Comparison between Current and Proposed Ebenezer Village PUD Design Standards

The development standards are outlined below with the current standards shown on the left and the proposed standards shown on the right. **Notable differences are shown in red text.**

FIGURE 6-800(B)(2): FRAMING OPEN SPACE

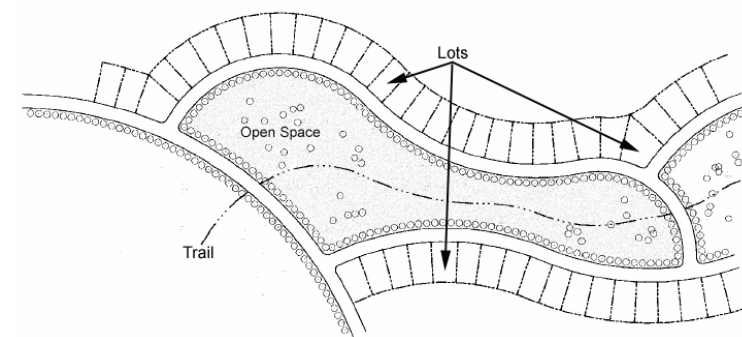
3. To the extent practicable, streets and single-family detached dwellings should be arranged to frame a substantial portion of the open space set-aside as indicated in Figure 6-800(B)(2), *Framing Open Space*.

FIGURE 6-800(B)(3): STREET FACING GARAGE DESIGN

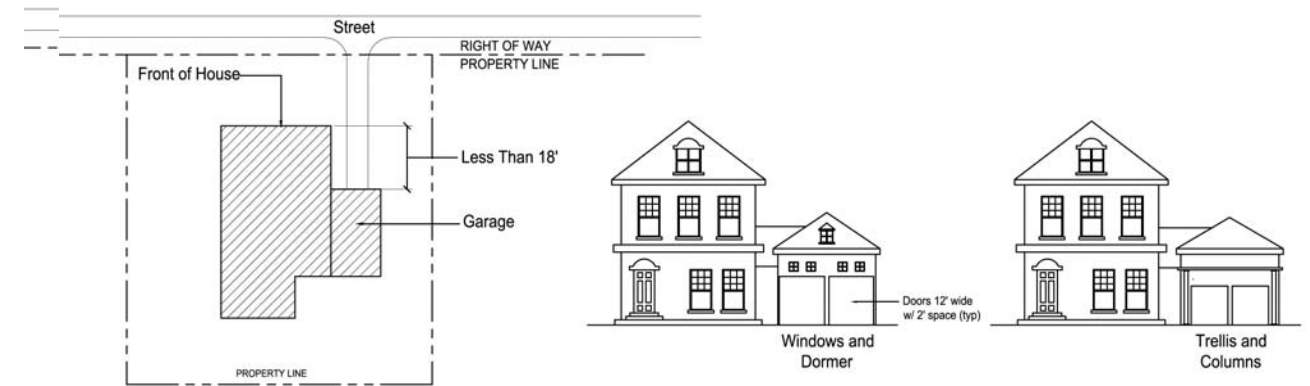
Except for garages setback from the right-of-way at least fifty (50) feet, and located on lots with a minimum lot size of one (1) acre or greater, garages shall be located so as to comply with the following standards as shown in Figure 6-800(B)(3):

- a. Except as allowed on lots with difficult topography or unique existing natural features, no street-facing garage shall be located closer than two (2) feet behind the primary front façade (conditioned space) of the single-family structure it serves;
- b. Any garage that is located less than eighteen (18) feet behind the front façade of the single-family structure it serves shall include a minimum of at least two (2) architectural features on the side including the garage door(s) (i.e. trellis, columns flanking doors, portico treatment, windows, dormers, overhangs, eaves, roof line changes, decorative vent covers, molding, etc.).

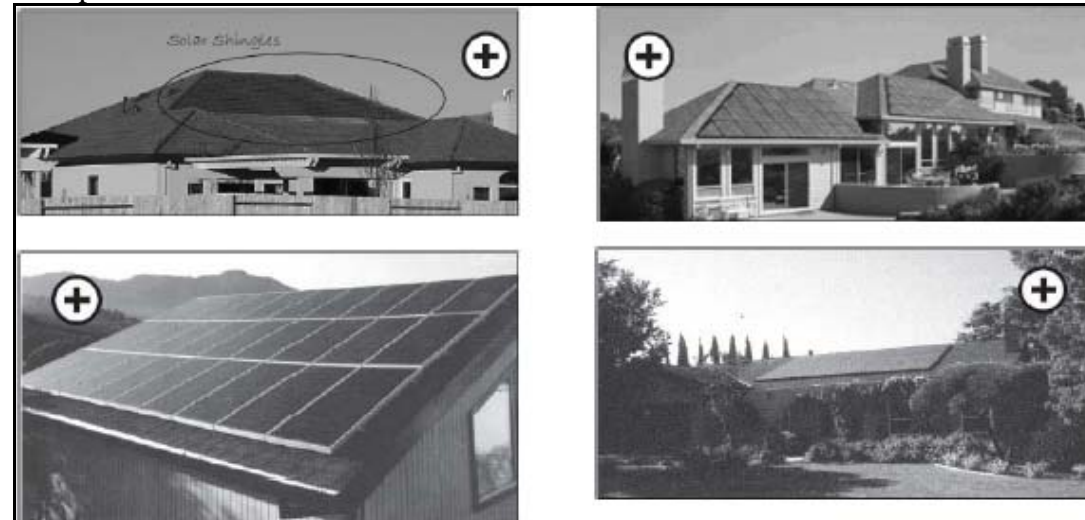
Additional standards that will apply that are not covered by the existing PUD:
